Indicates propose changes to approved planning application 2019/6088/P and approved LBC 2019/6270/L

Project
65 Kingsway - Base Scheme

Title
Demolition Section EE

Drawing No.
1914-BG-01-ZZ-DR-A-15.255

01 Demolition Section EE
15.202 1:100@A1, 1:200@A3

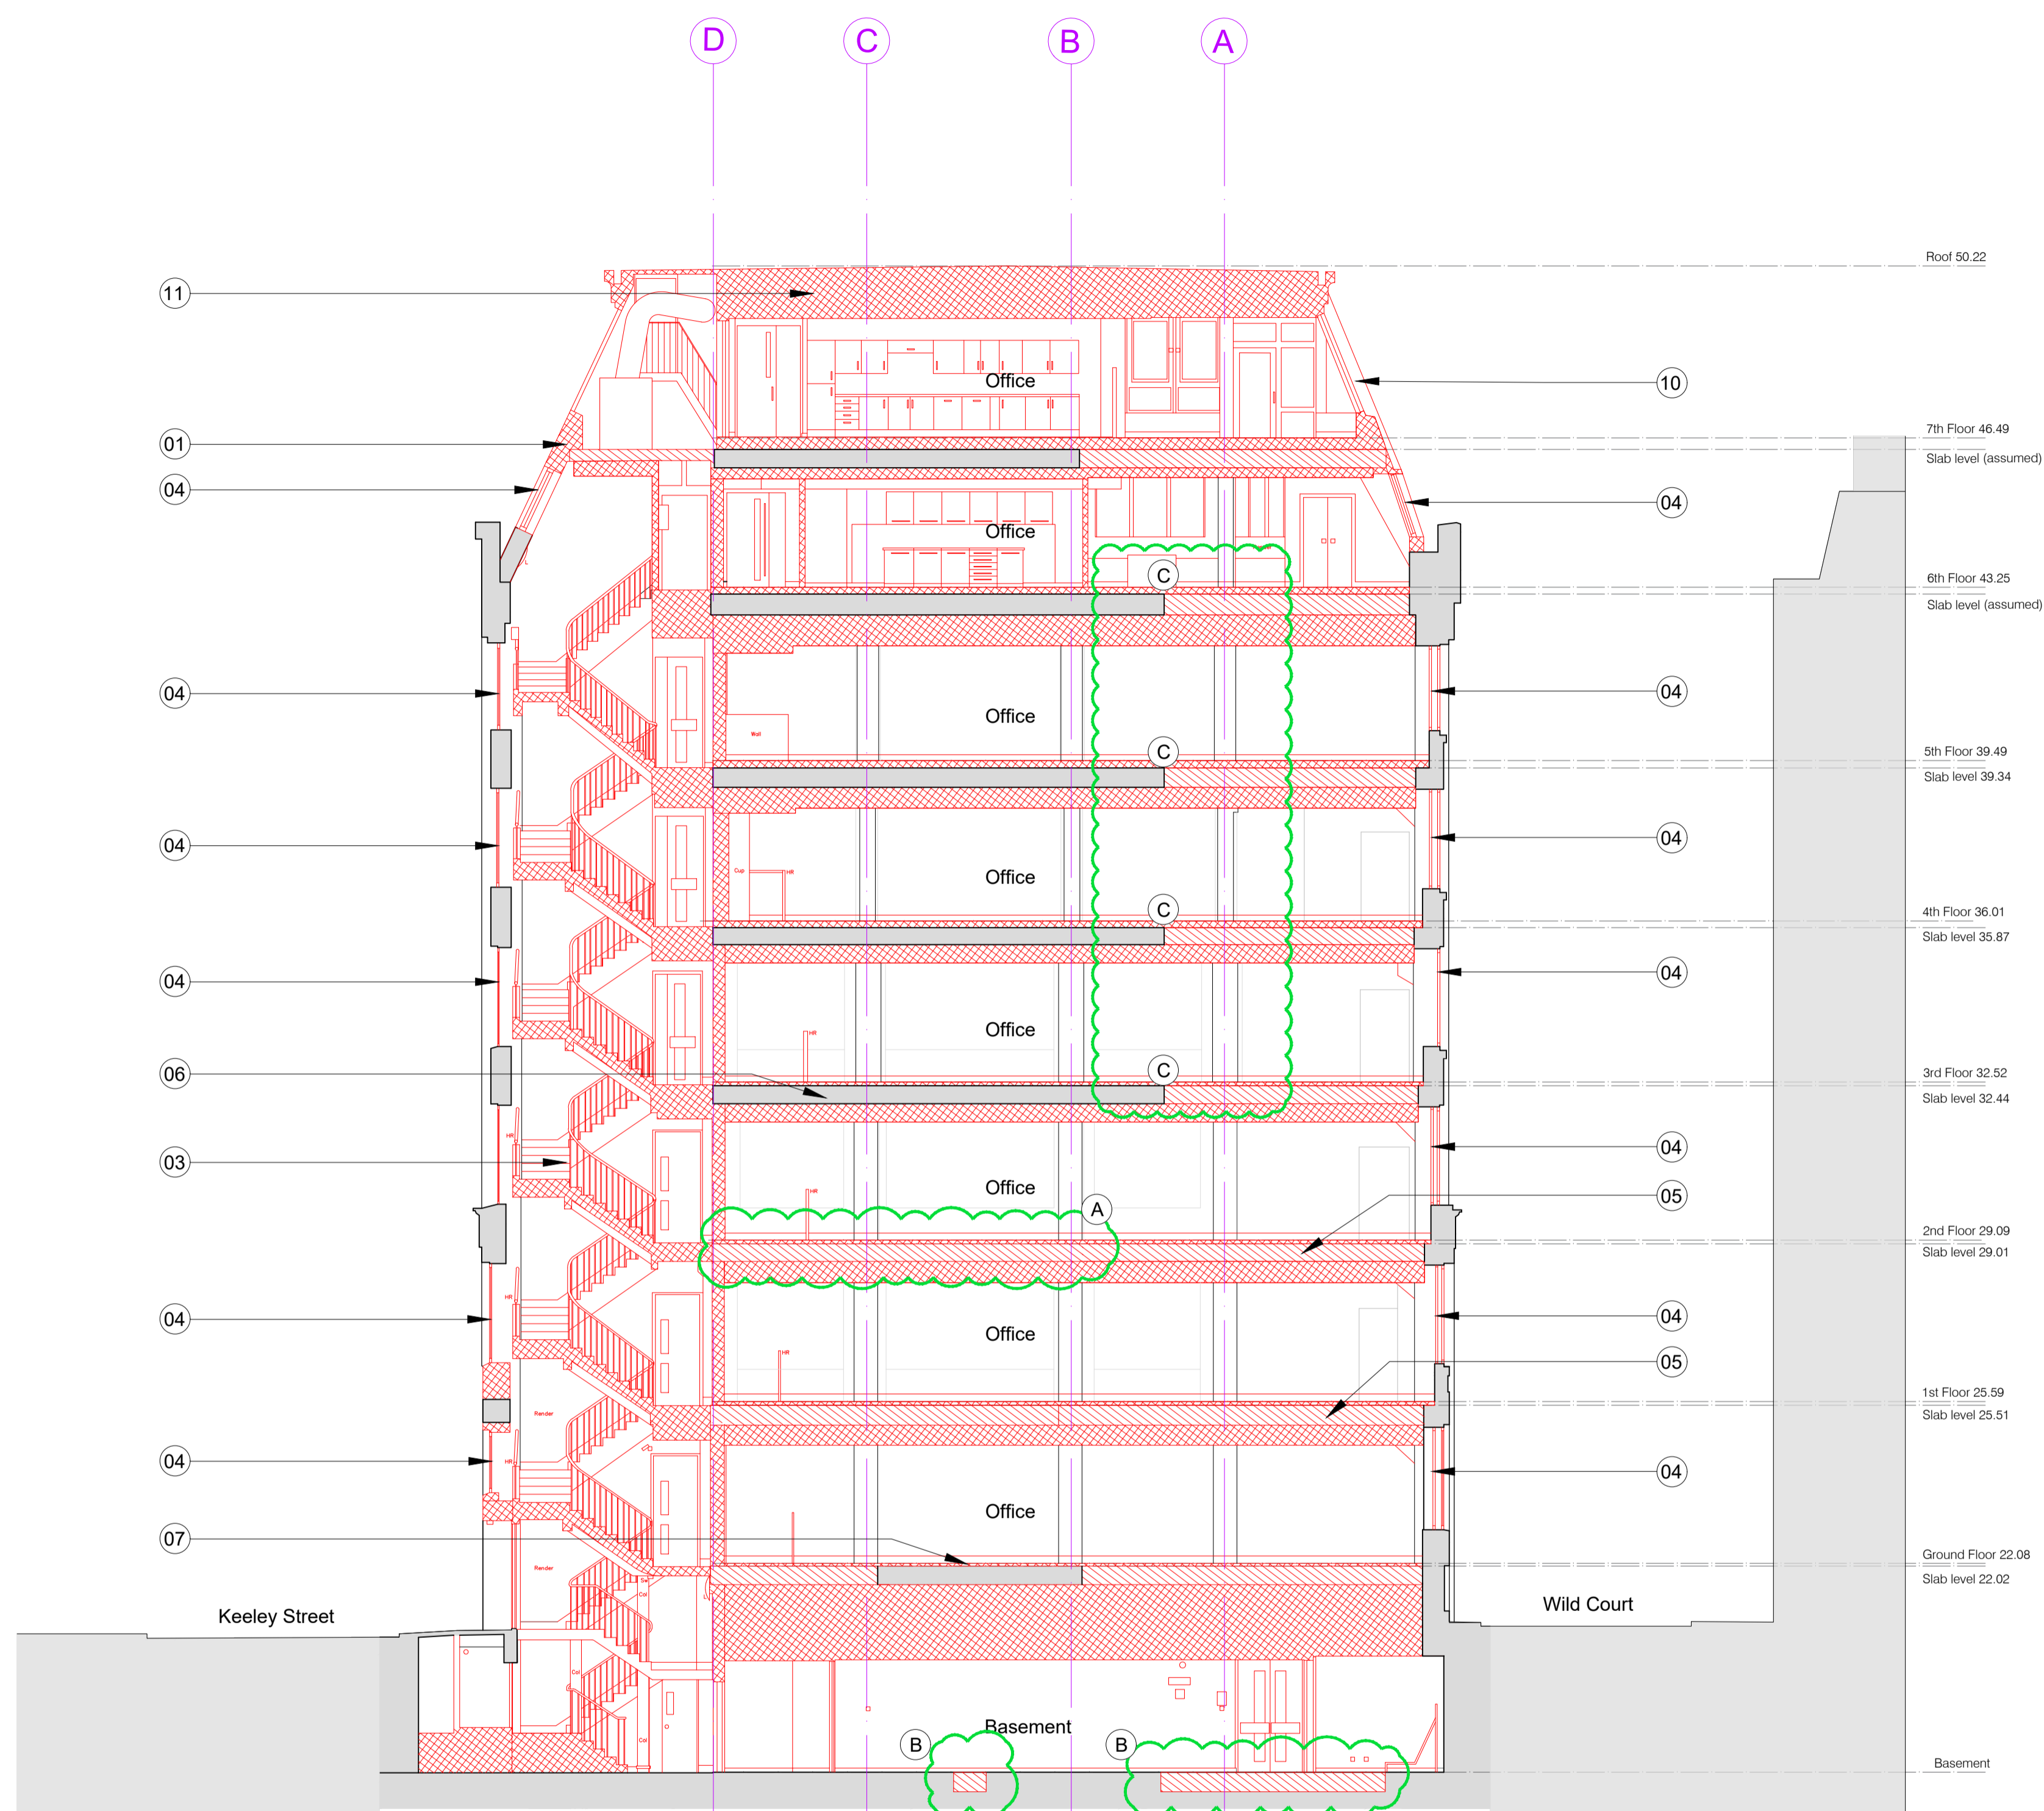
A. Slab demolition between Grid lines B-D/ 3-5, in order to facilitate the removal of the columns on 1F. See 15.203 First Floor Demolition plan. Refer also to HTS drawings and SK91.

B. Extent of slab demolition at Basement level for drainage route amended.

C. Reduced extent of slab demolition
